FORM APPROVED
OMB NO. 1004-0135
Expires: July 31, 2010**SUNDRY NOTICES AND REPORTS ON WELLS**
*Do not use this form for proposals to drill or to re-enter an abandoned well. Use form 3160-3 (APD) for such proposals.***SUBMIT IN TRIPLICATE - Other instructions on reverse side.**

Cimarex respectfully requests approval to plug back the Trinity 20 Federal Com #1 well and dual complete as a Cisco Canyon and Wolfcamp producer according to the following procedure:

Trinity 20 Federal Com #1

PROPOSED

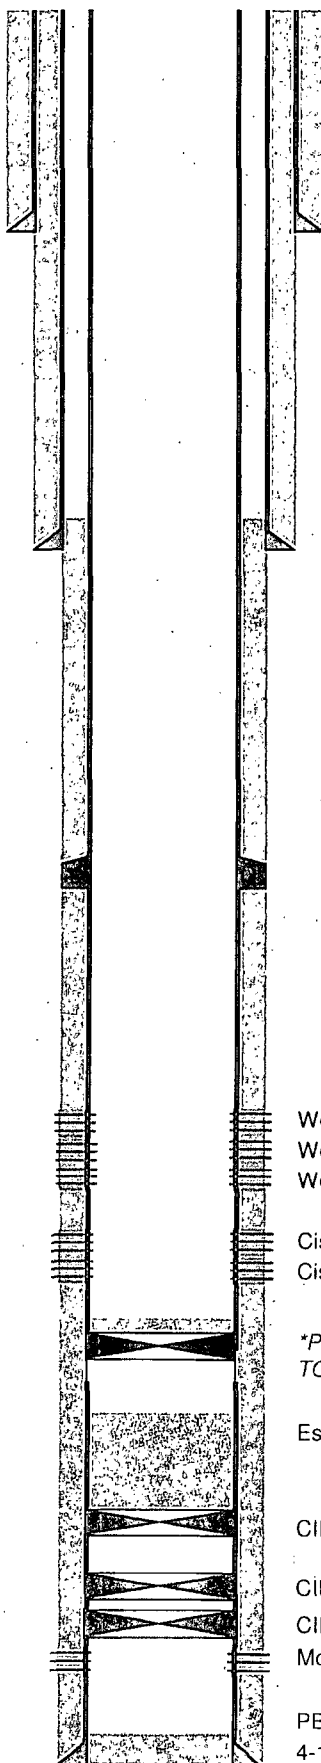
General COA requirements from Sundry dated 5/28/2014 and approved on 7/22/2014 still apply for Plugging back operations.

Subsequent sundry required detailing work done and completion report for the new formation. Operator to include well bore schematic with Tubing and Packer of current well condition when work is complete.

Approved as written
